**ADDENDUM #1 for:**

**Village of Oak Park Fire Sprinkler System Testing Services**

**Bid Number: 23-135**

**ADDENDUM Issue Date: 11/1/23**

**DIAGRAM - WATER SERVICE ENTRANCE**

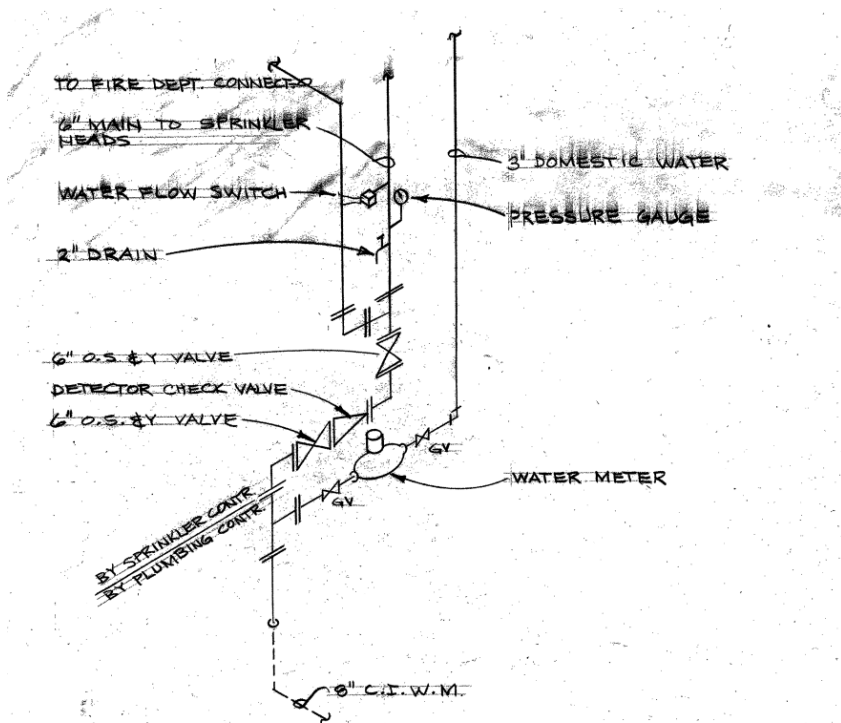
Install a new dual check-valve on the sprinkler system at the main fire station located at 100 N. Euclid.

Below is water entrance drawing from 1981. Sprinkler company shall inspect/verify actual existing conditions.

This is a link <https://www.watts.com/products/plumbing-flow-control-solutions/backflow-preventers/ames-deringer/deringer-2020g> to the company that makes this double check-valve 'Derringer' model line. Sprinkler company shall review what model would be best for this building based on the existing inlet size, existing pressure, recommended GPM, code requirements, etc.

There will be additional work required to remove the existing single check-valve, and the existing pipes will likely need to be shortened or lengthened on either side to accommodate the different size new dual check-valve. The system will need to be drained in order to perform this work. Work shall take place when sprinkler system testing for this location is scheduled (to avoid having to drain the entire system twice).
